Access Compliance Report

Public Rights-of-Way

(Curb Ramps)

Intersection ID: 3761	Main Street: KEENELAND_LN	Cross Street: CLAIBORNE_WOODS_RD	Location: NE
ADA ID: 8C204468AEC3	Ramp Type: Perp	Initial Pass/Fail: Fail	Overall Compliance: No
Severity Score: 21.25			
Codes/Mitigation Info/Possible Solution		Field Measurements/Component Compliance

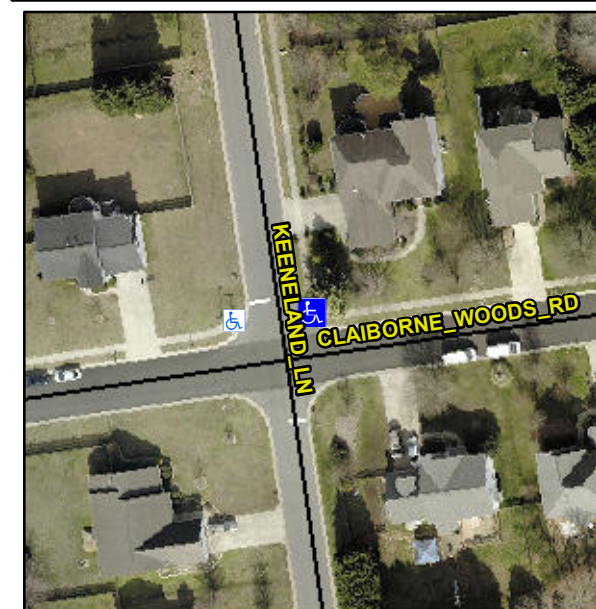
Not Found, R304.5.1, R304.5.3

Compliance	Description	Data	Compliance	Description	Data
N/A	Ramp Length (in)	46.0	Yes	Ramp Slope (%)	5.9
No	Ramp Width (in)	42.5	No	Ramp XSlope (%)	5.4
N/A	Flare Type LT	N/A	N/A	Flare Type RT	N/A
N/A	Flare Slope LT (%)	N/A	N/A	Flare Slope RT (%)	N/A
N/A	Flare Traversable LT?	N/A	N/A	Flare Traversable RT?	N/A
N/A	Landing Length (in)	N/A	N/A	DWS Provided?	N/A
N/A	Landing Width (in)	N/A	N/A	DWS Contrast?	N/A
N/A	Landing Slope (%)	N/A	N/A	DWS Length (in)	N/A
N/A	Landing X Slope (%)	N/A	N/A	DWS Full Width?	N/A
N/A	Landing Curb? (Y/N)	N/A	N/A	DWS Offset (in)	N/A
N/A	Shared Landing?	N/A			
N/A	Gutter Ponding?	N/A	N/A	Gutter Slope (%)	N/A
N/A	Gutter Lip Ht (in)	N/A	N/A	Gutter X Slope (%)	N/A
N/A	Painted X Walk1?	No	N/A	Painted X Walk2?	N/A
	X Walk 1 Direction	To W		X Walk 2 Direction	N/A
N/A	X Walk 1 Width (in)	N/A	N/A	X Walk 2 Width (in)	N/A
	X Walk 1 Slope (%)	7.8		X Walk 2 Slope (%)	N/A
	X Walk 1 X Slope (%)	1.6		X Walk 2 X Slope (%)	N/A

Remove & Replace Entire Ramp.
